No. EC155-31-030

SERVICE BULLETIN

Power supply modification of MFDAU equipment and CVFDR control panel

Corresponds to modification 0731C04

Figure 1

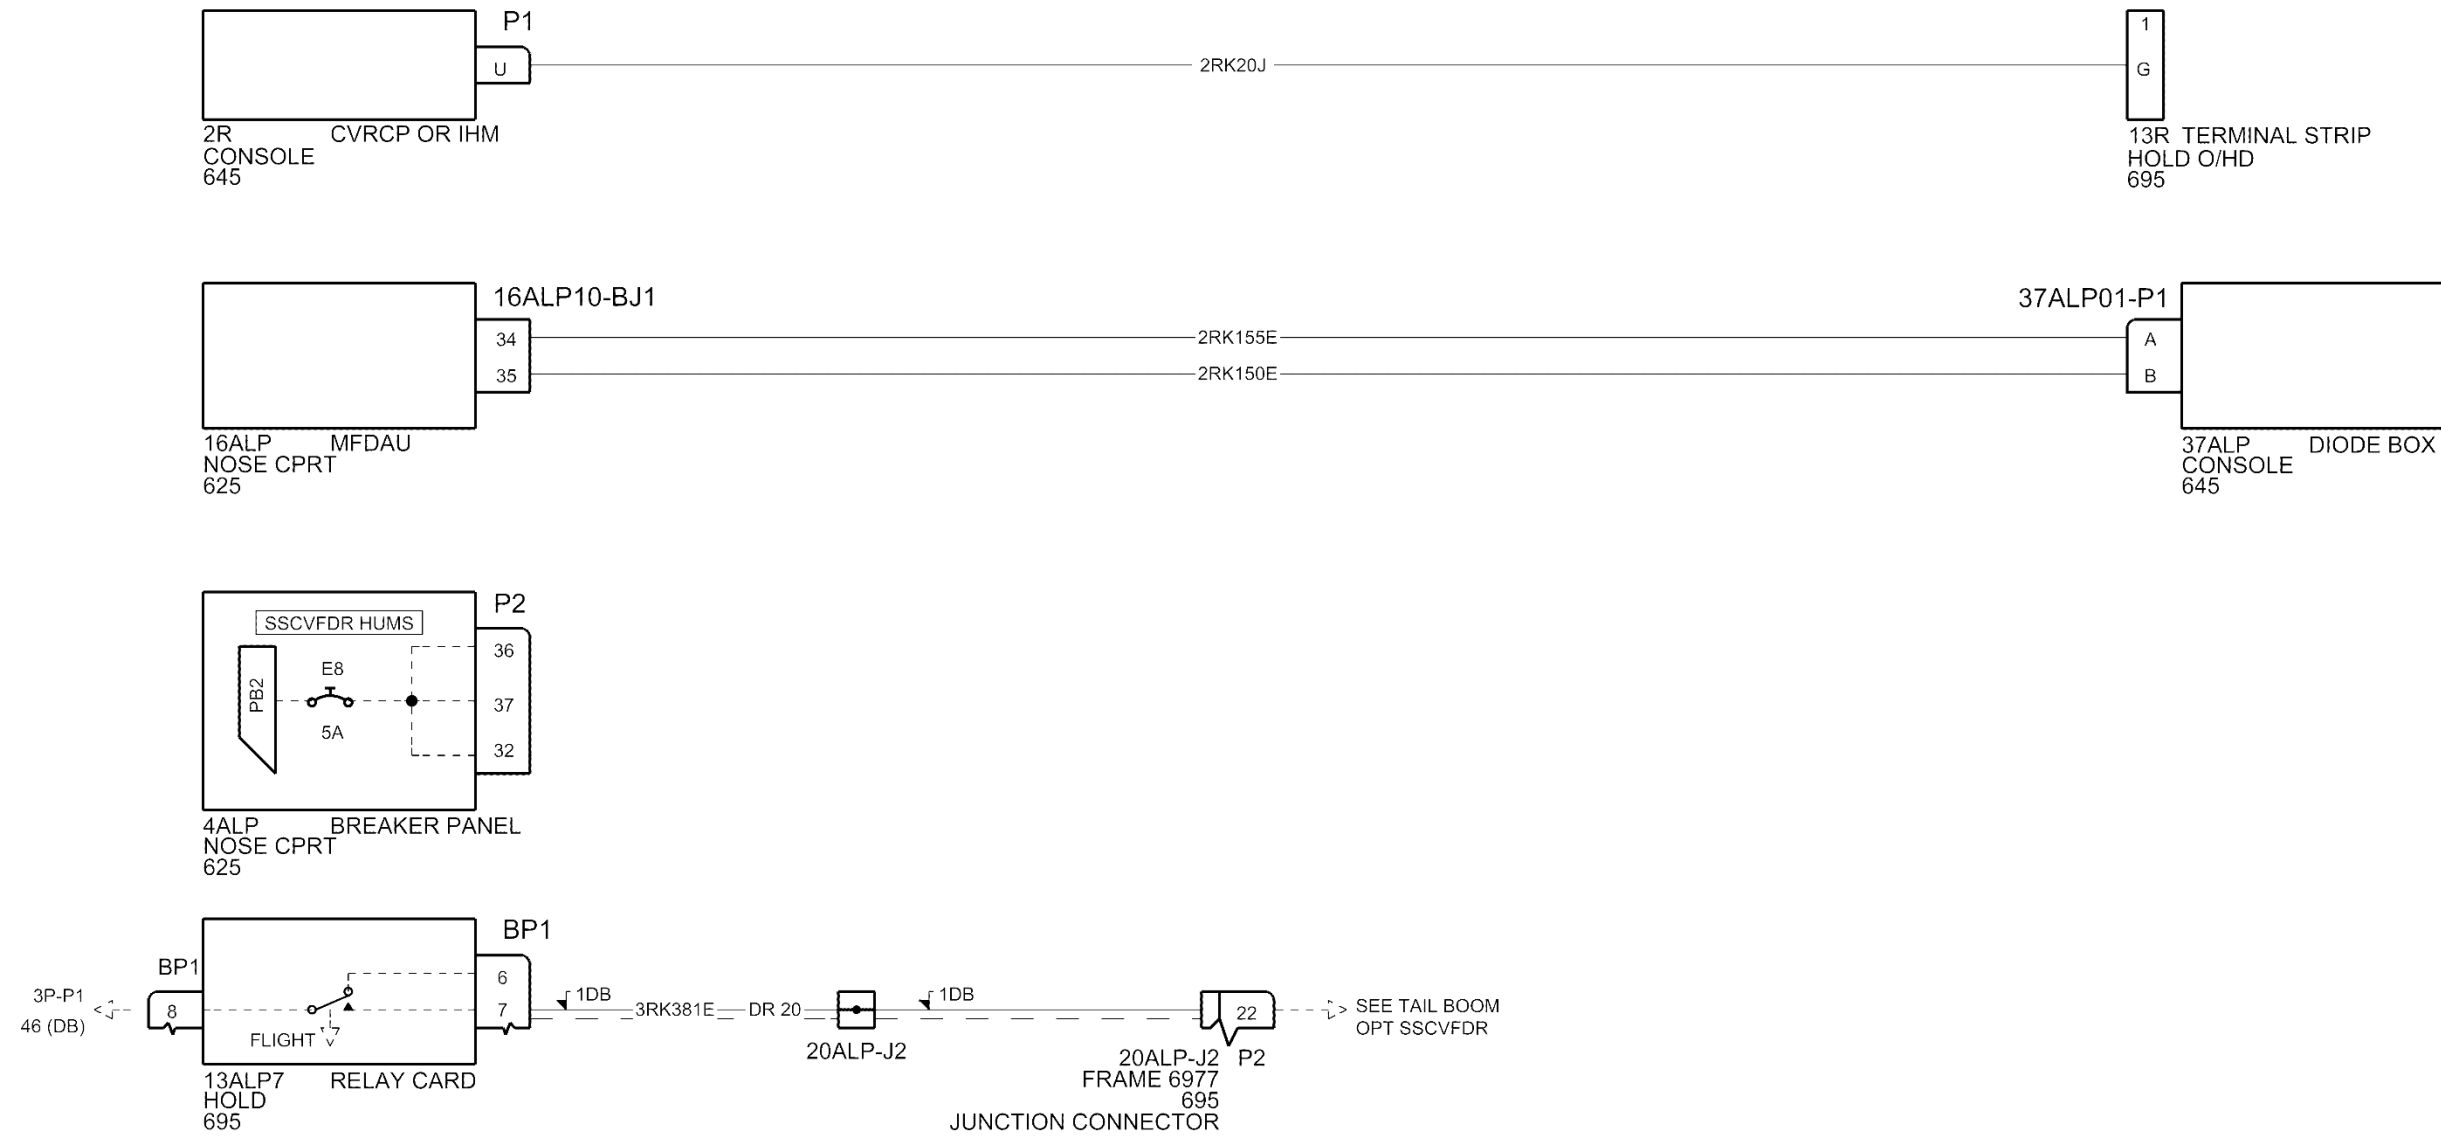
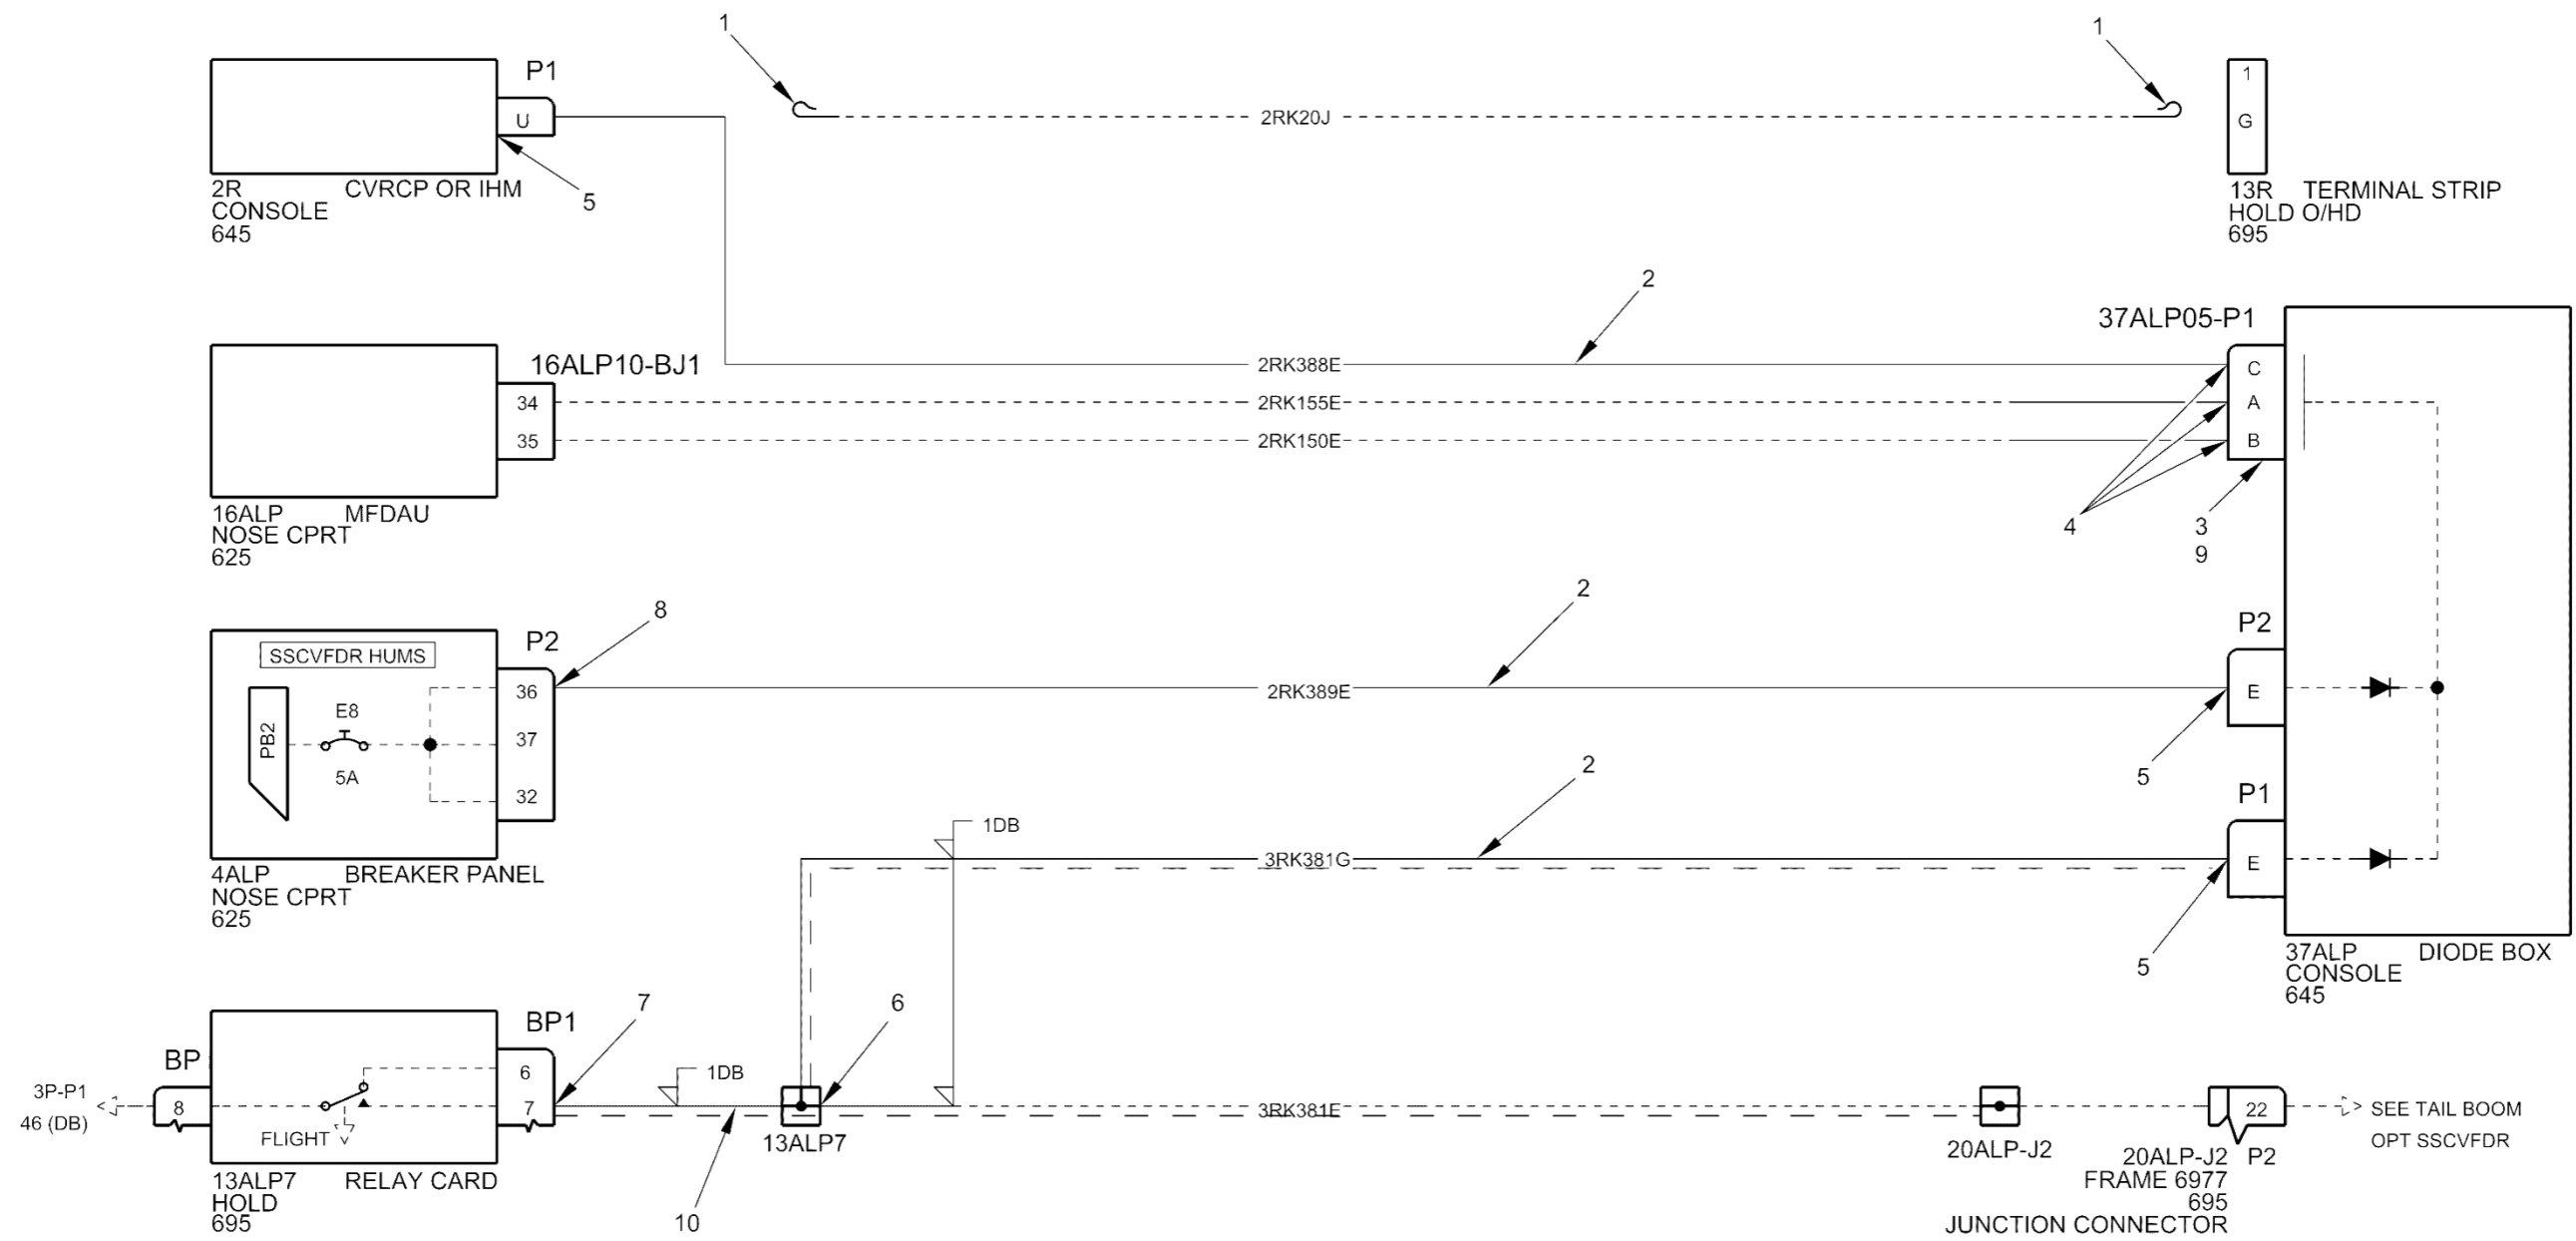
The function of this Service Bulletin is to modify the electrical wiring of the MFDAU and SSCVFDR-ED112 power supplies.

- Disconnect the wire "2RK20J".
- Install the cap (1) on the wire "2RK20J".
- Do the routing of the set of wires (2) and the cable (10). Refer to the indicated routings.
- Cut to the required length and connect the set of wires (2) with:
 - . The mobile box (3)
 - . The contacts (4), (5), (7) and (8)
 - . The extension lead (6)
 - . The module (9).
- Do a continuity test on the installed cables.

PRE MOD

POST MOD
